Access Compliance Report

Public Rights-of-Way (Curb Ramps)

| Intersection ID: 24195 | Main Street: PROVIDENCE_RD | Cross Street: BEVERLY_CREST_BV | Location: SE |
| ADA ID: DC443F0412D9 | Ramp Type: Perp | Initial Pass/Fail: Fail | Overall Compliance: No |

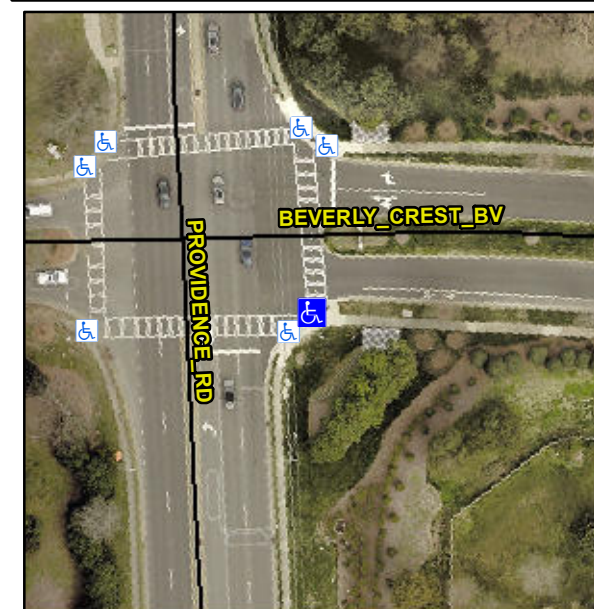
R304.5.1, R304.5.3

| Compliance | Description | Data | Compliance | Description | Data |
|------------|-----------------------|------|------------|-----------------------------|------|
| N/A | Ramp Length (in) | 50.0 | Yes | Ramp Slope (%) | 6.3 |
| No | Ramp Width (in) | 46.0 | No | Ramp XSlope (%) | 6.0 |

Remove & Replace Entire Ramp.
